TECHNICAL BULLETIN
Bell Helicopter **TEXTRON**
A Subsidiary of Textron Inc.

NO 407-00-24
DATE 03-17-00
PAGE NO. 1 of 10

SUBJECT: **ENGINE START CIRCUIT, ADDITION OF PULL UP RESISTOR TO IMPROVE FADEC START MODE LOGIC**

HELICOPTERS AFFECTED: 407, Serial Numbers 53000 through 53267.

Figure 1. Wire and Resistor – Installation on Module

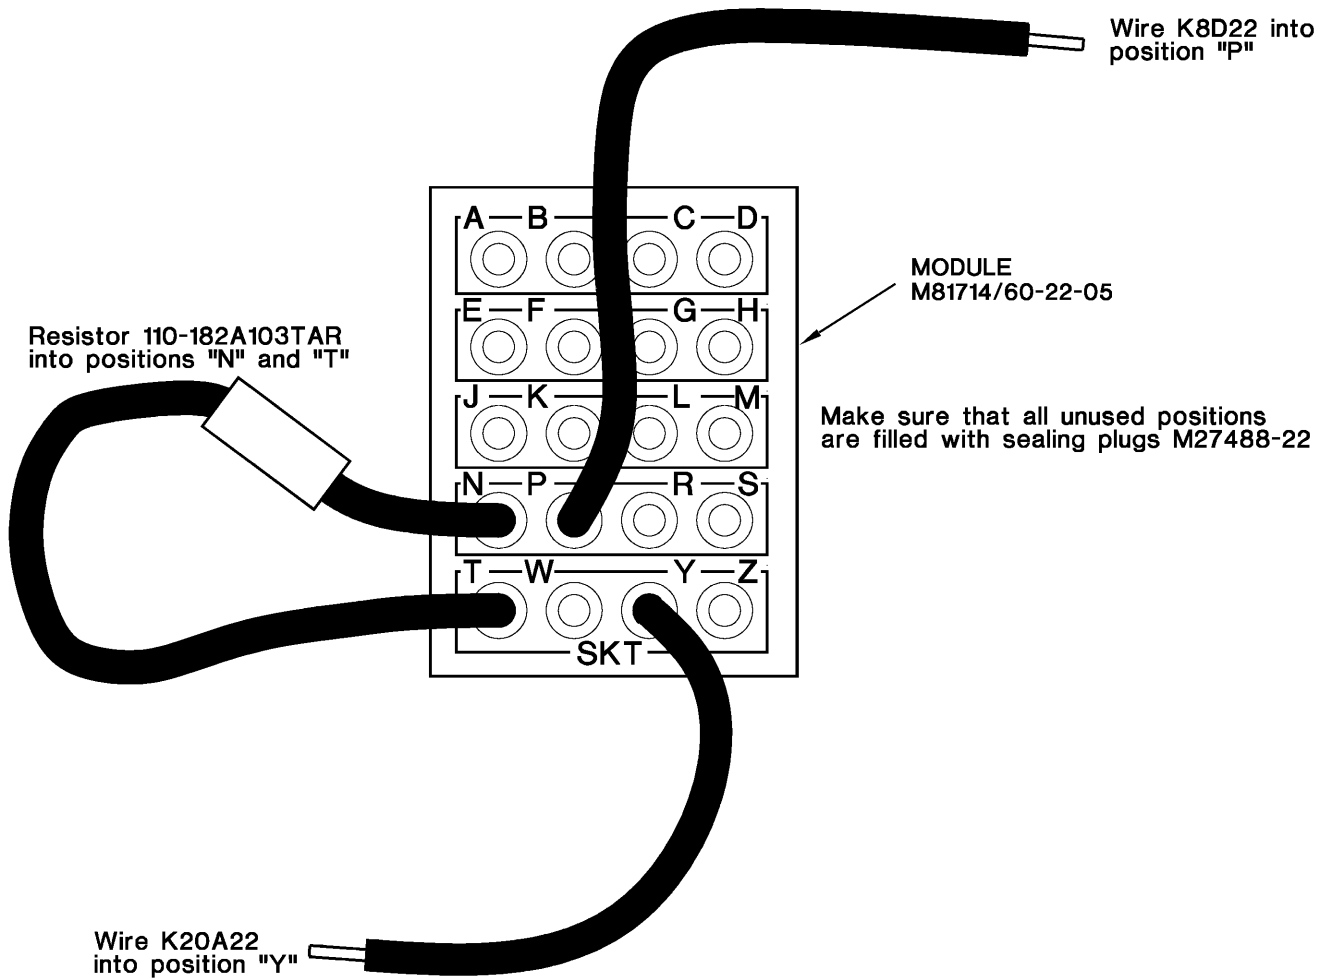
5. Use the insertion tool M81969/16-04 to insert one end of the wire K8D22 into position "P" on the uninstalled module M81714/60-22-05. Refer to Figure 1 and to BHT-ELEC-SPM, Section 5-00-00.

7. Use the insertion tool M81969/16-04 to insert wire K20A22 into position "Y" of the uninstalled module M81714/60-22-05. Refer to Figure 1 and to the BHT-ELEC-SPM, Section 5-00-00.

9. Use insertion tool M81969/16-04 to insert the contacts of the resistor 110-182A103TAR (reference designator 8R8), into positions "N and T" of the uninstalled module M81714/60-22-05 (Figure 1). Install the 16 sealing plugs MS27488-22 into all the remaining open positions of module M81714/60-22-05.

Refer to Accomplishment Instructions, and install wires K8D22, K20A22 and resistor 110-182A103TAR (reference designator 8R8) into module M81714/60-22-05 before you install the module into terminal block 8TB3.

Figure 2. Wiring Detail – Post T.B.

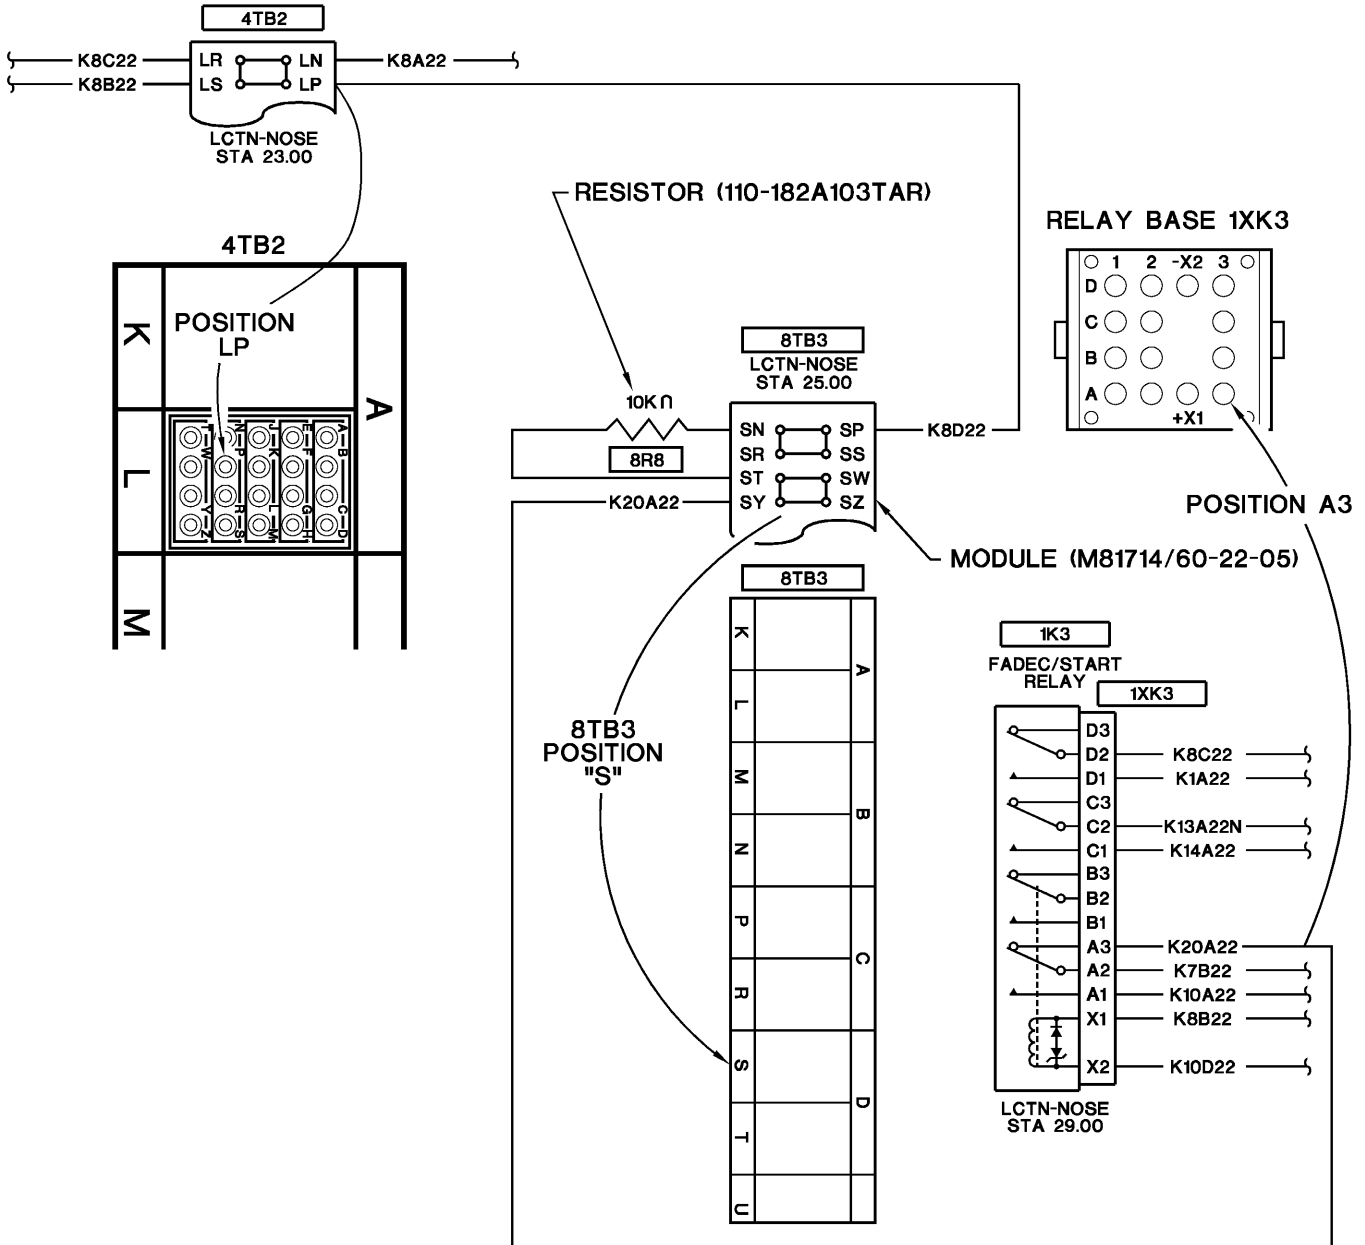
12. Use finger pressure to install module M81714/60-22-05 with the installed wires K8D22, K20A22 and resistor 110-182A103TAR (reference designator 8R8), into position "S" of 8TB3.
13. Put the wire K20A22 along the existing harness to the FADEC/start relay base 1XK3.
14. Use the insertion tool M81969/16-01 or M81969/14-10, to install the contact of wire K20A22 into position "A3" of FADEC/start relay base 1XK3 (Figure 2).
15. Use finger pressure to install the FADEC/start relay base 1XK3 to the mounting rail.

16. Use finger pressure to install the FADEC/Start Relay 1K3 to the relay base 1XK3.
17. Put the wire K8D22 along the existing harness to terminal block 4TB2 position "LP". Use the insertion tool M81969/16-04 to install the contact of wire K8D22 into position "LP" of Terminal block 4TB2 (Figure 2).

- b. After you install the wire K8D22 into module position "P", install module into 4TB2 position "L" with finger pressure (Figure 2).
19. Make sure the wires K8D22 and K20A22 are installed correctly and securely held to wire bundles with lacing cord (EC-052). Ensure resistor 110-182A103TAR (reference designator 8R8) is left in free air and supported so that no interference occurs. Refer to BHT-ELEC-SPM, Section 6-00-00.

To provide clarity, other existing modules in 4TB2 and 8TB3 have not been shown.
